I hereby certify that this **AMENDMENT IN RESPONSE TO THE OFFICIAL COMMUNICATION MAILED ON SEPTEMBER 9, 2005** accompanied by Transmittal Form PTO/SB/21, Extension of Time Request, Fee Determination Sheet form PTO/SB/06, and a postcard receipt, is being deposited with the United States Postal Service by Express Mail Receipt No. EV 491170847

Serial Number: 10/689,246

For: MICRO COMPONENT LIQUID HYDROCARBON REFORMER SYSTEM AND CYCLE FOR  
PRODUCING HYDROGEN GAS

**Figure 1**

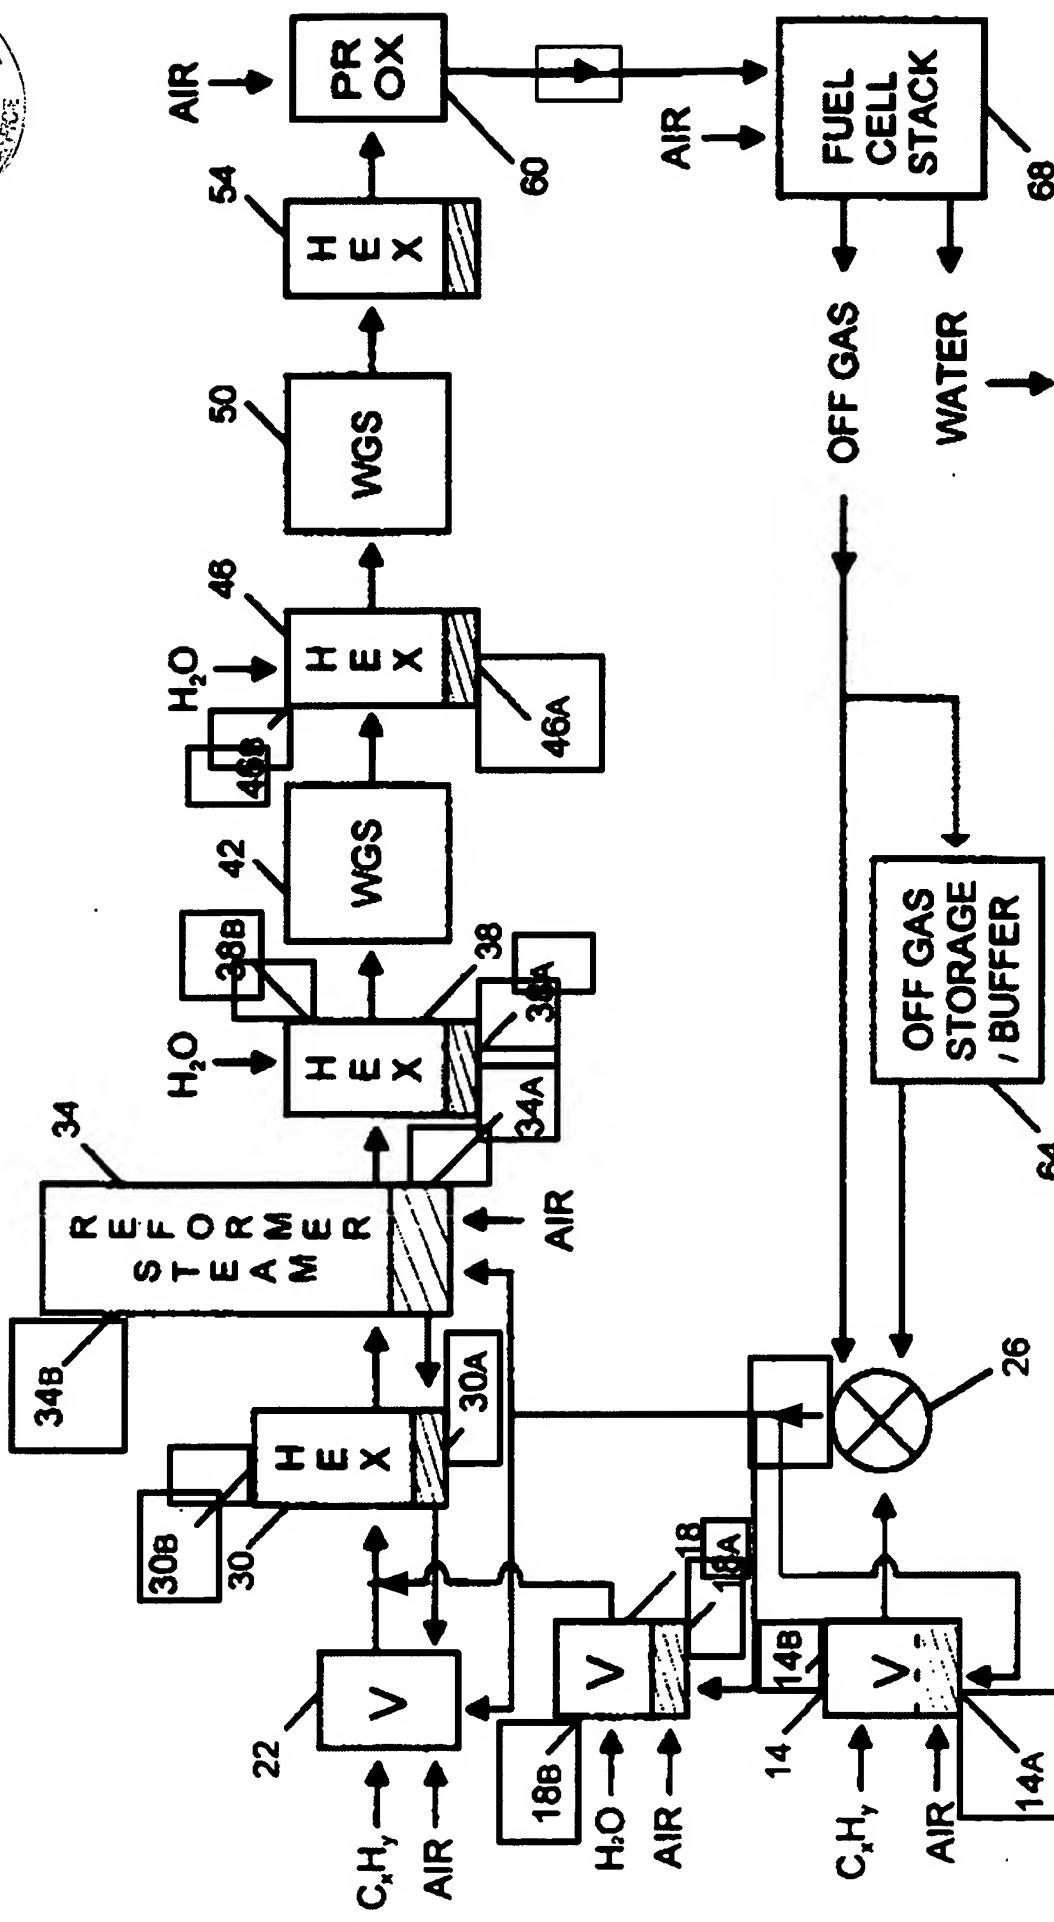
A corrected drawing sheet for Figure 1 marked "Replacement Drawing" is submitted with this amendment. The corrections to Figure 1 cure the objections to the reference numerals, flow depictions, and references in the specification pointed out by the Examiner. Paragraph [0035] is amended to refer to flow channels 331 and 332 in Figure 3C.

Superfluous reference numbers in Table II are deleted and replaced by "in" and "out" references to conform the table to corresponding modules shown in Figure 1 as amended.
